Application Number:	**AWDM/1193/25**	**Recommendations:** **1) S.73A Minor Amendments with variation of planning conditions - Approve** **2) S106 Obligation Amendments - Approve**
Site:	**Land At Former 5 Brighton Road, Shoreham-By-Sea**	
Proposal:	**Application to vary condition 2 (approved plans) Condition 21 (District Heat Network) of previously approved AWDM/1962/22 and Variation of S106 Agreement.: Amendment: Basement removal, reallocation of Floor Area between V4 and V1 Town Houses. Different sustainable and energy efficient solution has been produced.** **ORIGINAL DESCRIPTION: Proposed mixed-use re-development between 3 and 8 storeys comprising of 21 townhouses, mixed-use apartment block of 24 flats, commercial unit, riverside walk, play area, landscaping, and parking (with revised design and provision of on-site affordable housing).**	
Applicant:	Cayuga 011 LLP	Ward: Southwick Green

Introduction

This application was deferred by Committee at the meeting of 19th March. It concerns the approved development of 45no.dwellings, comprising 24no.townhouses and an apartment block of 21no. Apartments (referred to as 'block v4') with a small riverside commercial unit, at the former

Figure 1 - Visualisation from Brighton Road (looking West)

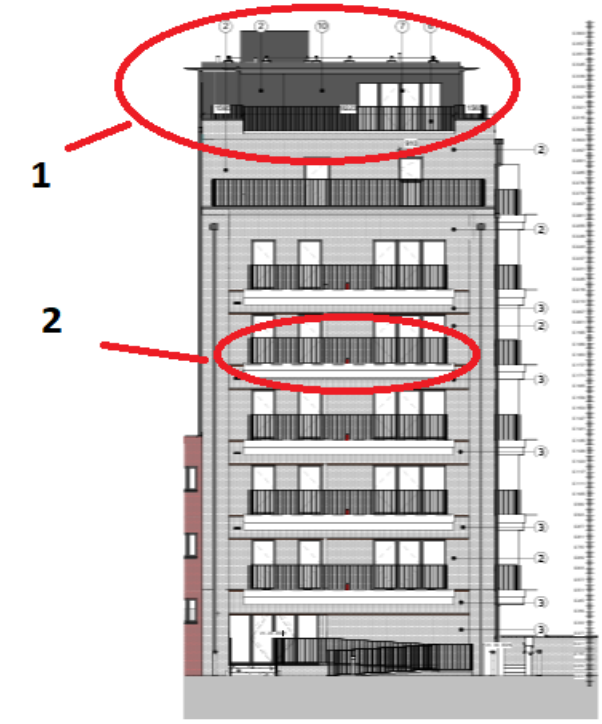
The two visualisations depict the Eastern aspect of the proposed development with specific focus towards Block V4. These two visualisations are intended to better illustrate the effect of the (now) revised penthouse layer to V4 and the enclosed walkway featured to its Eastern elevation (which remains fundamentally unchanged since the preceding Committee meeting). Members will likely recall that these components of the proposal attracted the most debate during the previous Committee meeting in respect of matters of design.

Figure 3 - Northern elevation to Block V4. Previous plan included to right for purposes of comparison. (Not shown to scale).

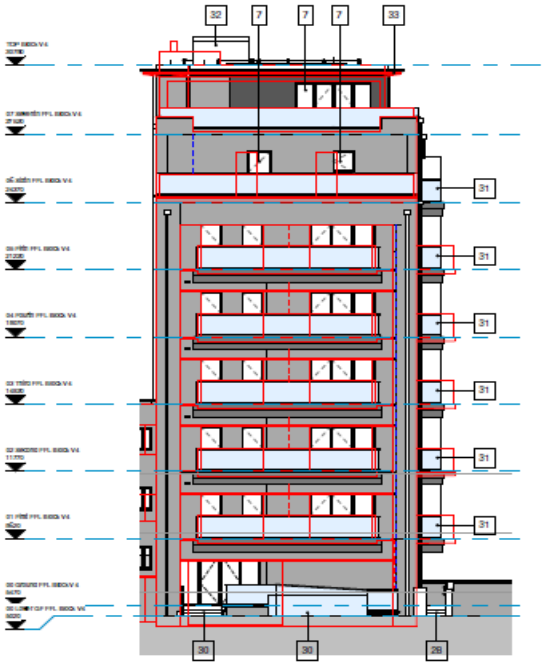
The proposed penthouse layer is now proposed to omit brickwork in its entirety, making greater use of cladding panels. This change is highlighted as change No. 1 at Figures 3 and 4 below, with the reduced quantity of brickwork particularly evident within the northern and eastern elevations to Block V4

In response to the revised plans now received, the view of officers is that these show a positive change to the proposed penthouse layer and design quality of the scheme overall. The increased quantity of glazing within the penthouse layer allied with the reduced quantity of brickwork better distinguishes the penthouse layer from its respective storeys below. Subject to detailed consideration of the precise quality, colouring and type of cladding and reflective panel material, to be reserved for approval pursuant to a condition requiring the submission and approval of material details, it is considered that the revised plans describe a penthouse layer appropriately subservient to the main 7x storey tower and which is of lightweight design as originally envisaged within the original appeal approval.

Figure 4 - Eastern elevation to Block V4. Previous plan included to right purposes of comparison. (Not shown to scale).

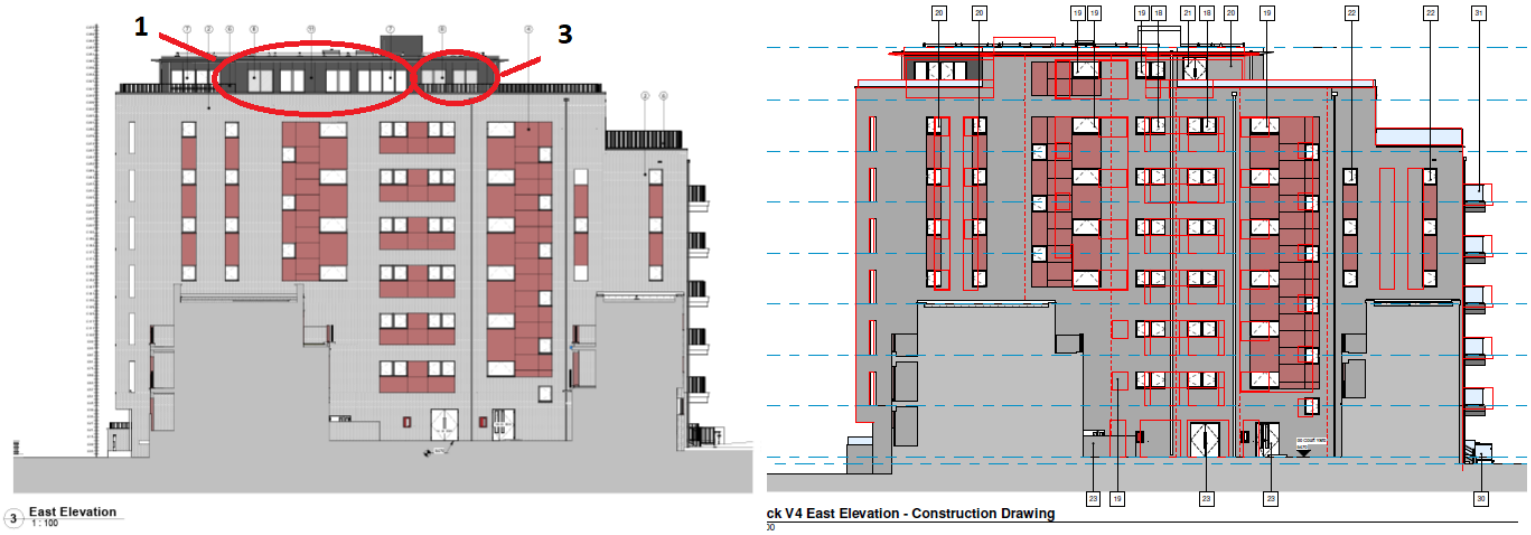
Allied with this change, the revised plans show an increased number of windows featured to the eastern elevation of the penthouse, together with a number of reflective glazed panels where the introduction of windows is prohibited by the internal layout of the penthouse layer. These reflective panels are highlighted at Figure 4 below as change No.3.

Members will note that the revised plans do not describe any significant change to the treatment of the previously enclosed walkway featured to the eastern elevation of Block V4, other than the introduction of an additional cladding panel, as was a matter of concern within the previous debate and the previous officer recommendation to

Figure 6 - Southern elevation to Block V4. Previous plan included to right for purposes of comparison. (Not shown to scale).

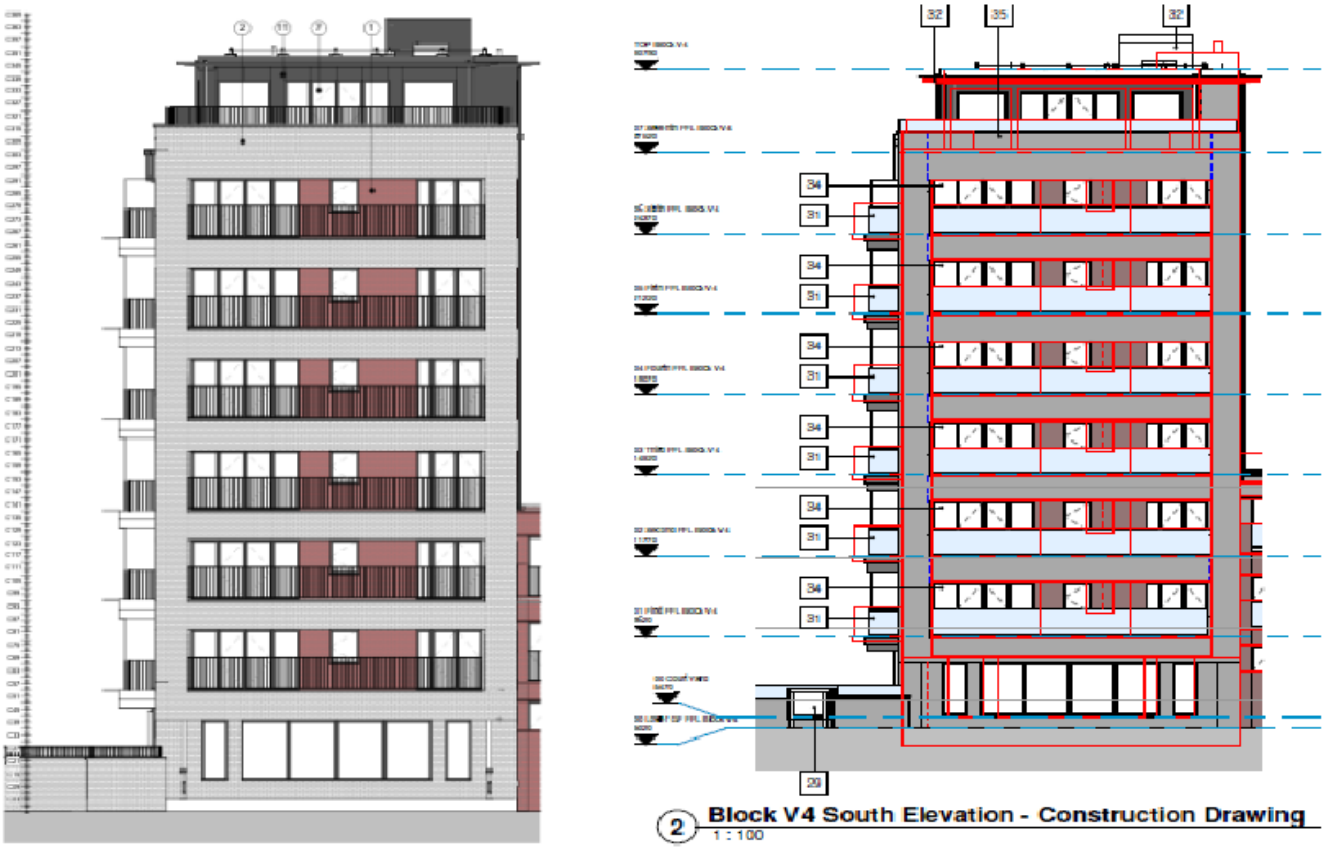
The revised plans, finally, describe the use of metal balustrading to balcony and ramped-access spaces, as highlighted as change No.2 at Figure 3 below. This change, however, should be noted to apply to the entirety of Block V4 and its conjoined townhouse blocks (V1 and V3).

The proposed change from glazed to metal balustrading is neither considered detrimental nor beneficial to the design quality of the proposed development such that the effect of this change is neutral.
